SAWMILL CREEK ADDITION

RE: S/D 99-87 -- Final Plat of SAWMILL CREEK ADDITION

RE: S/D 99-87 -- Final Plat of SAWMILL CREEK ADDITION

CASE NUMBER: S/D 99-87 -- SAWMILL CREEK ADDITION

SAWMILL CREEK ADDITION

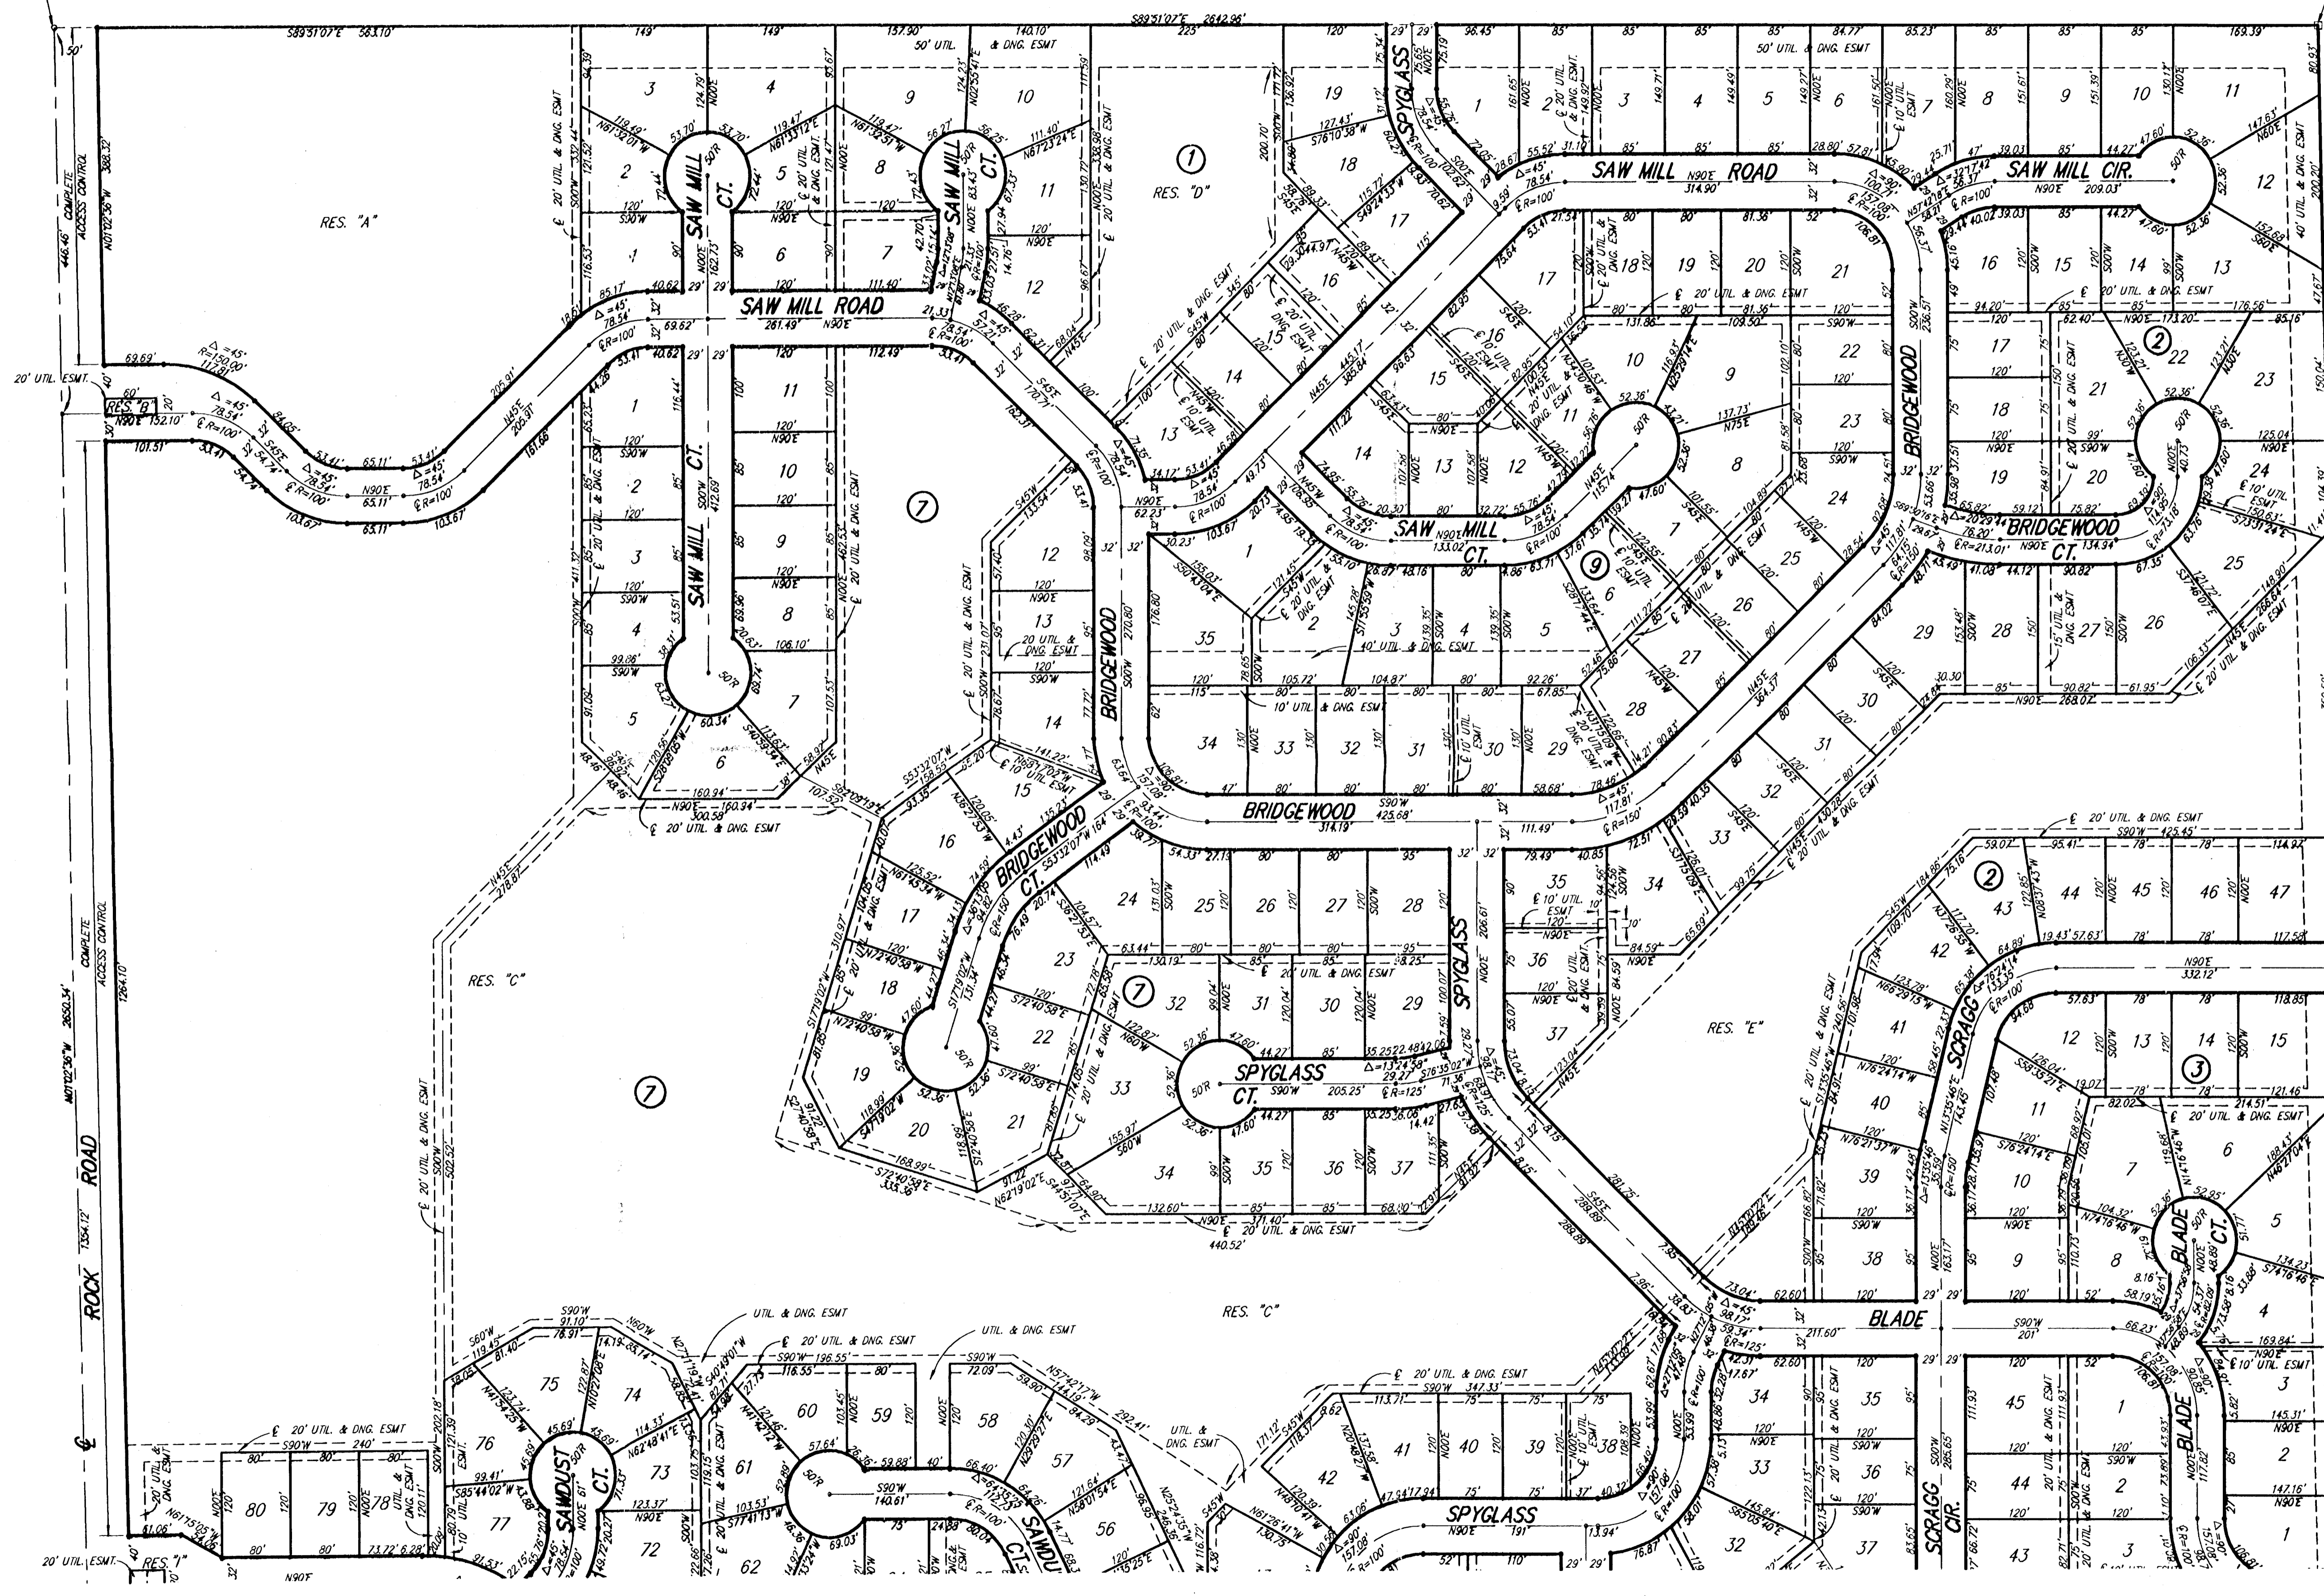
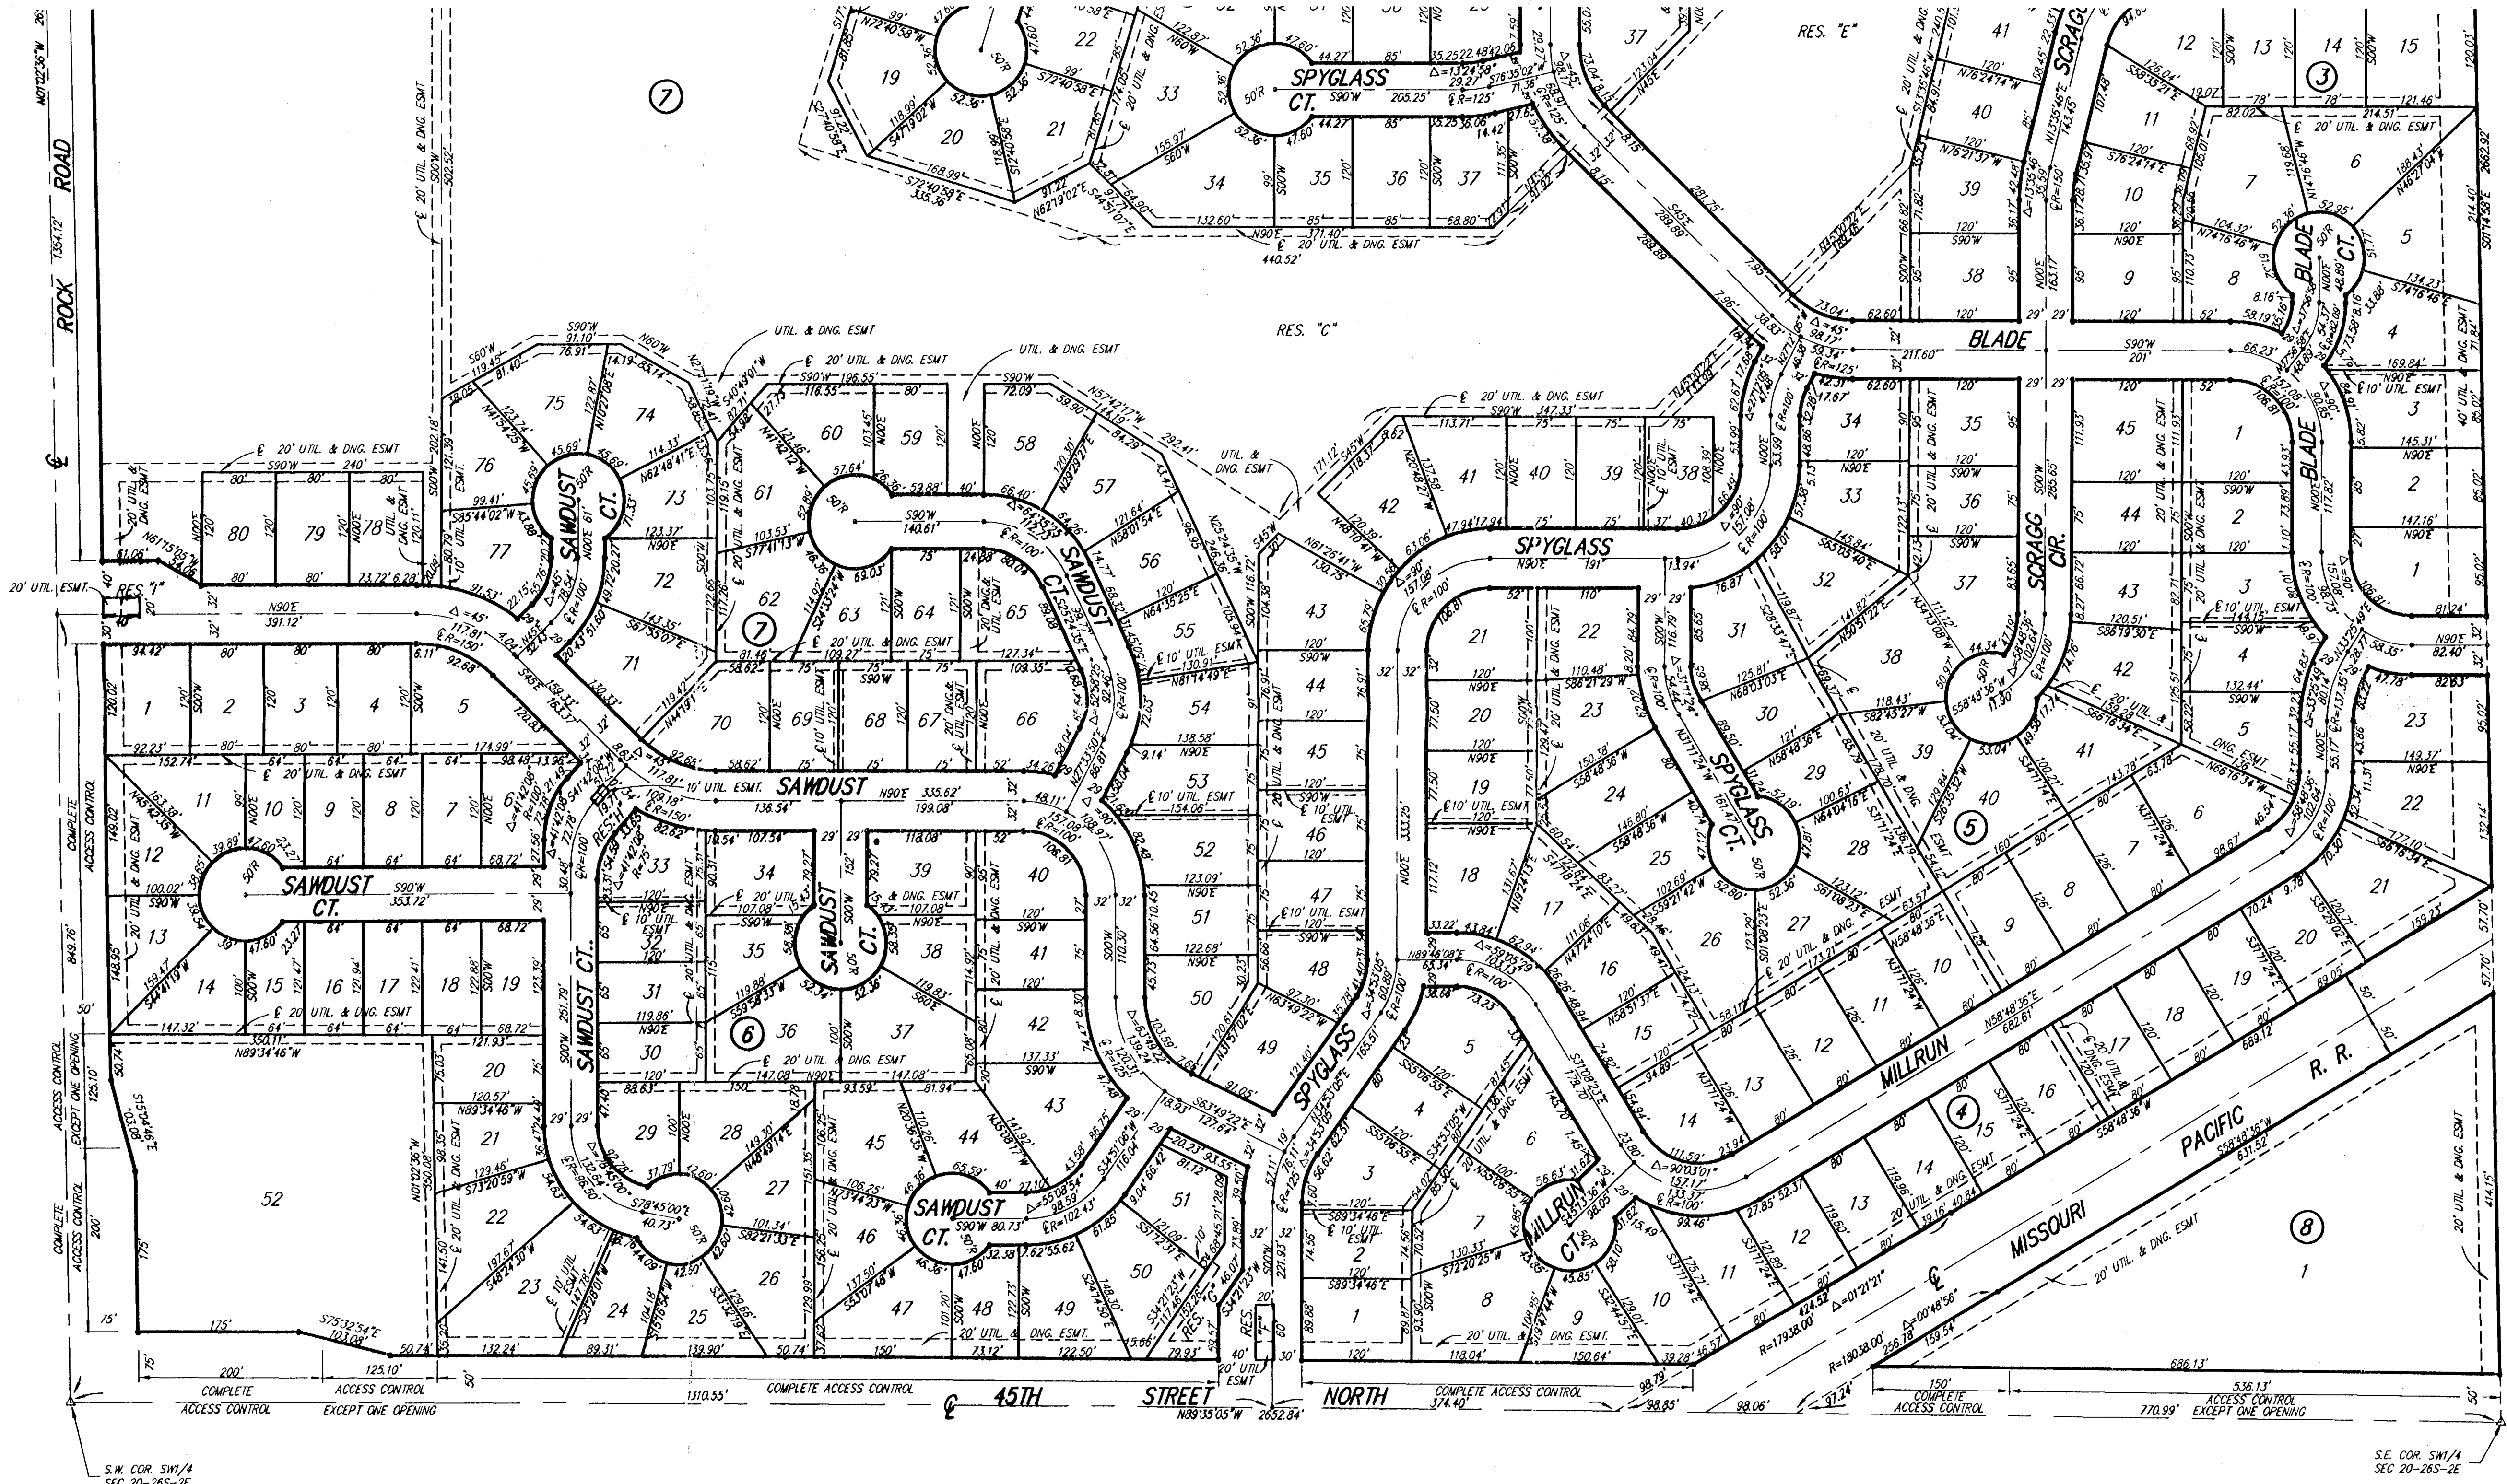
- A. City Engineering needs to comment on the need for guarantees or easements. The applicant shall provide a guarantee for the extension of municipal water and sewer. A sewer layout is requested. An off-site sewer easement is needed. Utility easements shall be added to Lot 1, Block 8.

- D. City/County Engineering needs to comment on the status of the applicant's drainage plan. County Engineering requests a drainage plan for review. The minimum pad elevations need elevations. City Engineering has approved the drainage plan. A drainage guarantee is required.

H. The right-of-way widths for perimeter streets shall be denoted.

O. The benchmark elevations should be checked.

P. Reserve B needs to be located.

Q. Road rights-of-way near Reserve B, Reserve F, Reserve H, and Reserve I need to be dimensioned.

R. Curve data at the west end of Saw Mill Road on the north side needs to be labeled.

S. The utility and drainage easement labeled on Lot 9, Block 1, needs to be changed to 40 feet.

T. The following items need to be labeled: easements on Lot 13, Block 7; Lot 27, Block 2; Lots 29-34, Block 7; road right-of-way on the northwest corner of the plat; curve data near

Reserve H on the east and west sides of the road; property line information on Reserve G; point of intersection (P.I.) on Lot 14, Block 4 bearing southwesterly; P.I. on the northwest line of Lot 1, Block 8 bearing southwesterly; and widths of Access Control along Lot 1, Block 8 and Lot 52, Block 6.

- U. The following items need to be located: easement in Reserve C near Lot 16, Block 7; easement on Lot 38, Block 5; easement in Reserve C near Lot 38, Block 7; easement in Reserve E near Lots 38 and 39, Block 2;

- V. Reserve H needs to be dimensioned.
- W. The applicant shall submit a covenant which provides for four (4) off-street parking spaces per dwelling unit on each lot which abuts a 58-foot street. The covenant shall inventory the affected lots by lot and block number and shall state that the covenant runs with the land and is binding on future owners and assigns.

The final plat has included the requested access strips.

The applicant has included two street stubs to the east and one stub to the north.
